BP # 30033 V RJs

CP 81-4-15
C-3 Zone
[illegible] Fontaine Ave
3 Story Type III 1 hr
Occup. A2.1/B-2
Valuation $400,000
[illegible] = 1163.00 ←
SMIPA = 33.00
[illegible] = 6000.00
[illegible] = 12000.00
$ ~~[illegible]~~
$ [illegible]

INTERIOR ALTERATIONS & ADDITIONS
FOR PIZZA TIME THEATRE, INC.
2445 FONTAINE ROAD, SAN JOSE, CALIFORNIA

SHEET NO.
S-1
OF 2

MEZZANINE FLOOR PLAN

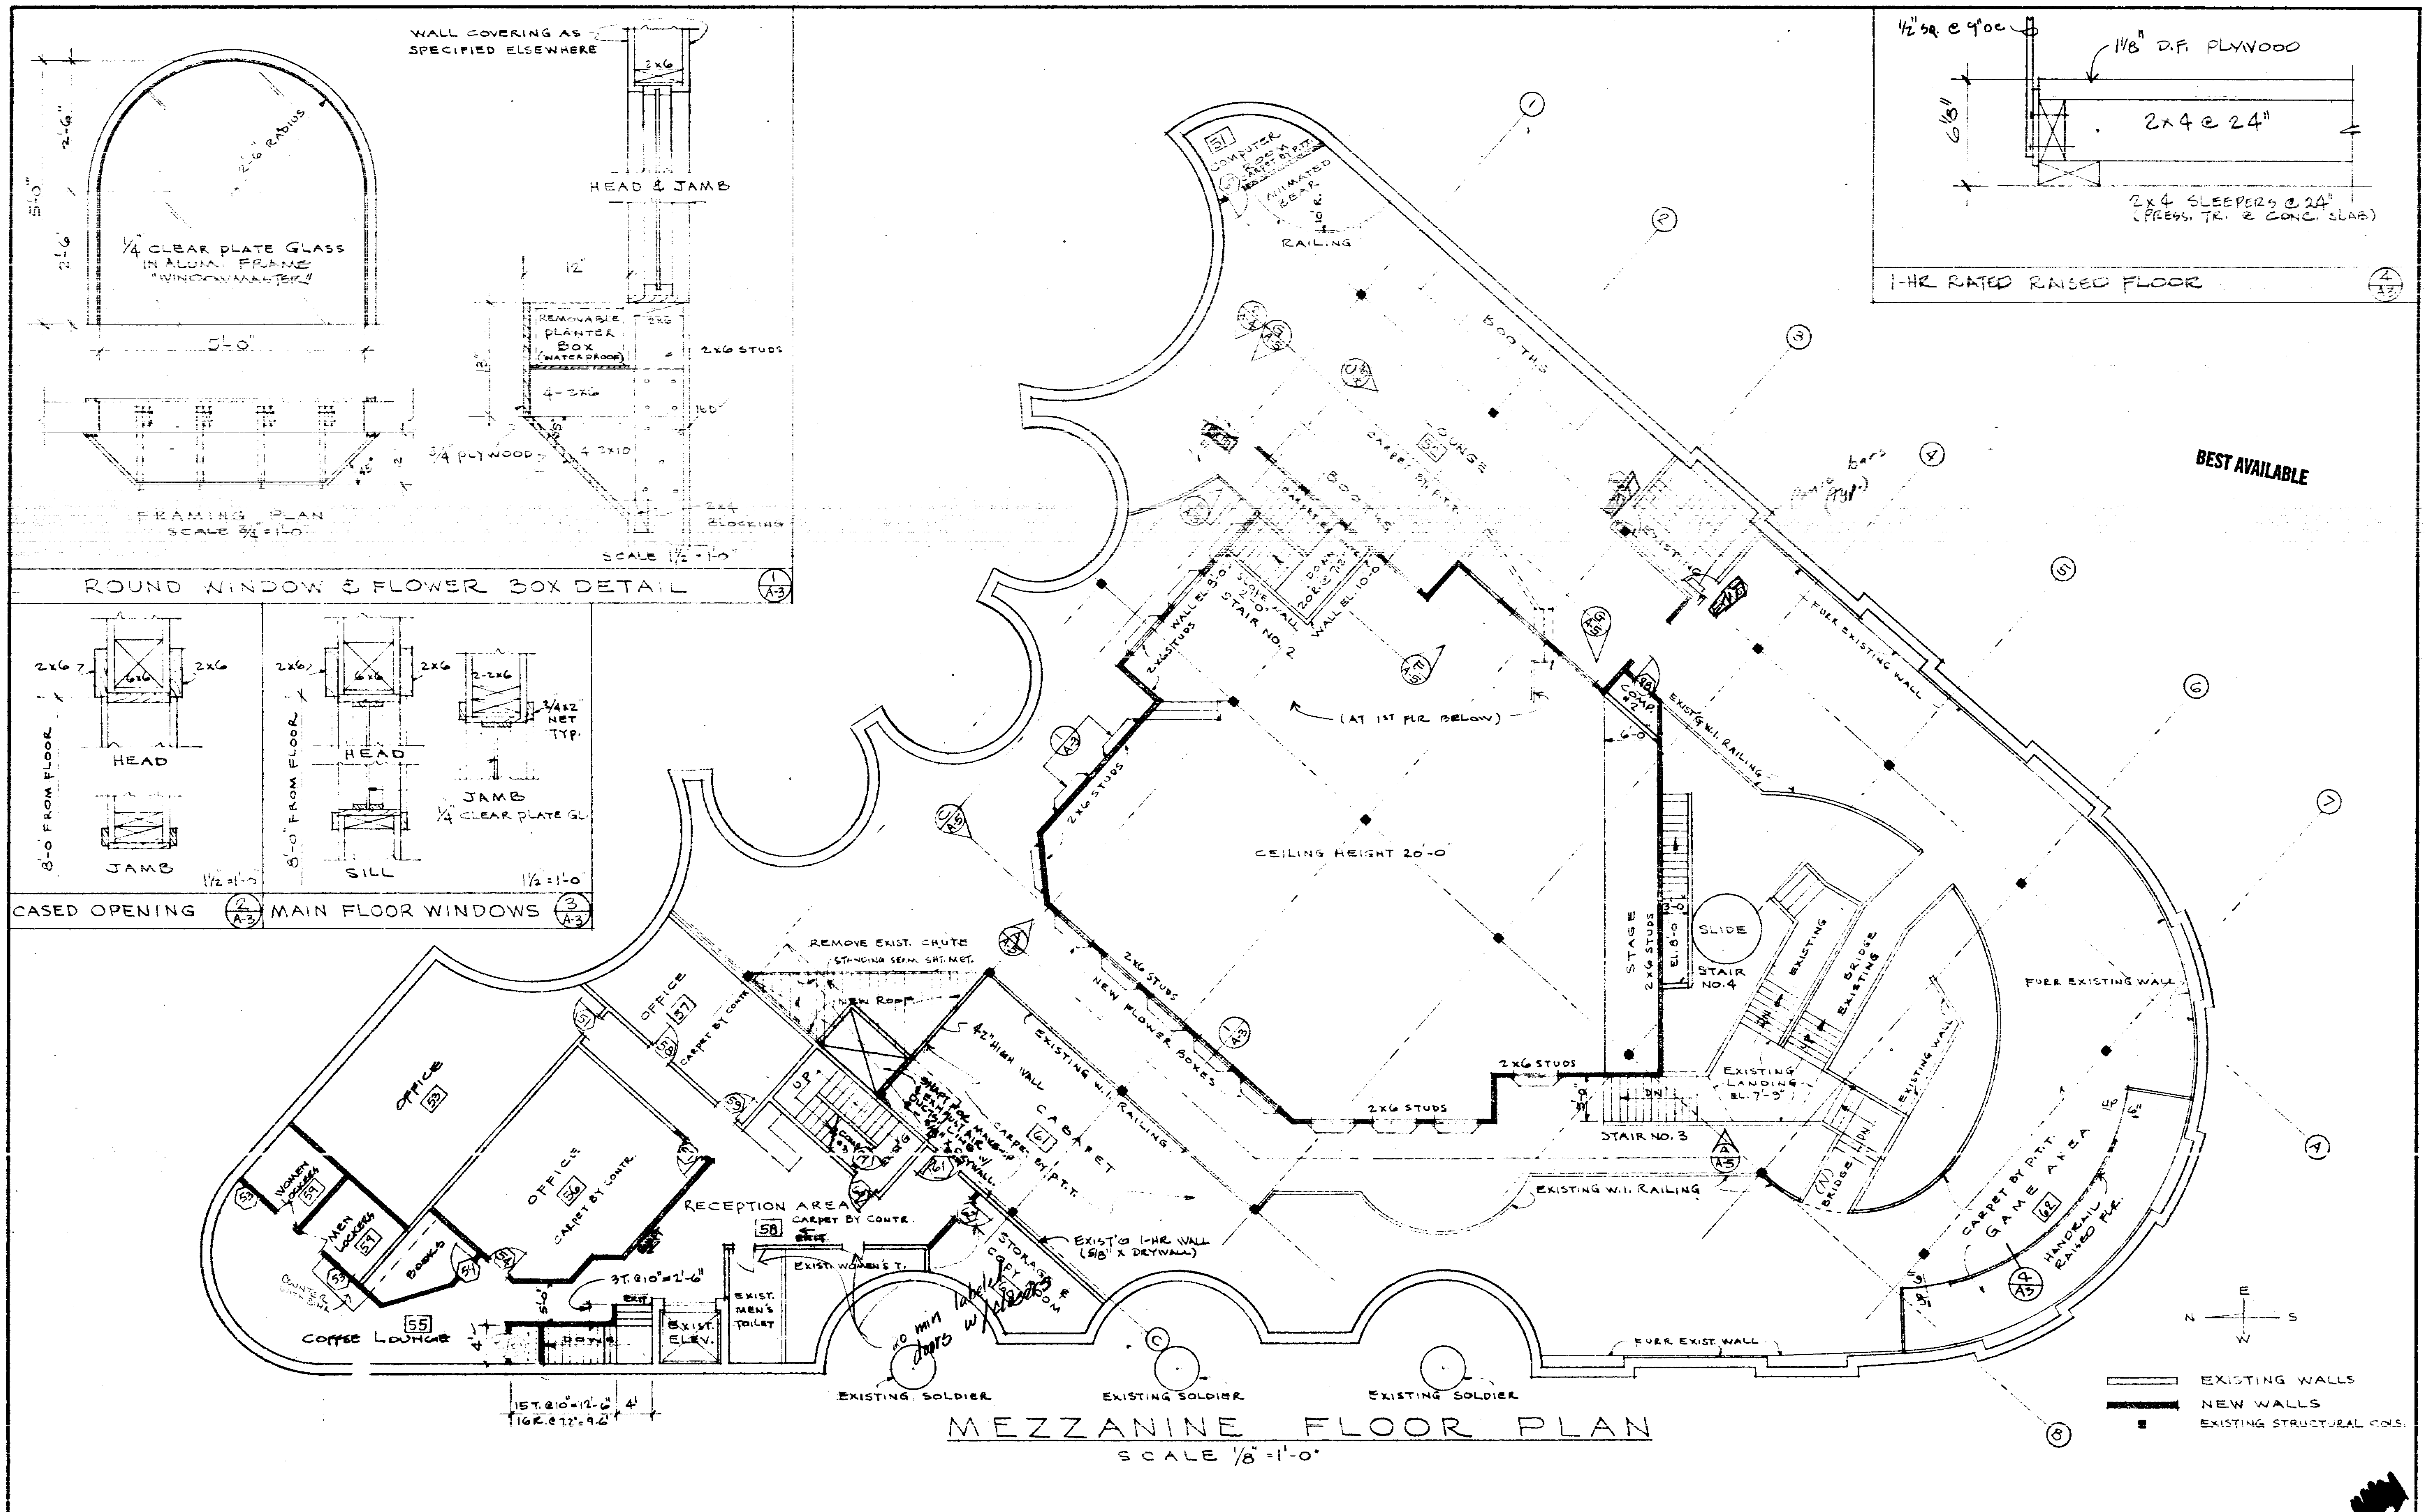
EXIST'G ROOF BM.
2x4 @ 24" VERT
2x4 @ 4'
2x4 BRACES @ 4' OC.
1/2" DRYWALL ON 2x4
ATTIC DRAFT STOP 1/4"=1'-0" 5/A-4
Provide Engineered Connection
Suspended ceiling
1
2
3
4
5
6
7
A
B
C
FURR. WALL TYP.
EXISTING WINDOWS
NEW ATTIC DRAFT STOP. MAX. ATTIC AREA BETWEEN DRAFT STOPS = 9,000 SQ. FT.
5/A-4
ATTIC SPACE - SUSPENDED CEILING AT 20'-0" FROM FL.
PROVIDE SEISMIC BRACING
EXIST'G WALL CONTINUOUS TO ROOF.
OFFICE 3
OFFICE 3
OFFICE 3
TEST KITCHEN 54
OFFICE & RECEPT. 4
52
DN
EXIT
EXIST. ELEV.
STOR. 5
63
EXIST. LADDER TO ROOF
EXISTING SOLDIER
EXISTING SOLDIER
EXISTING SOLDIER
WHAT WILL THIS BE USED FOR
(OFFICE FUTURE)
EXISTING WINDOWS
N
S
E
W
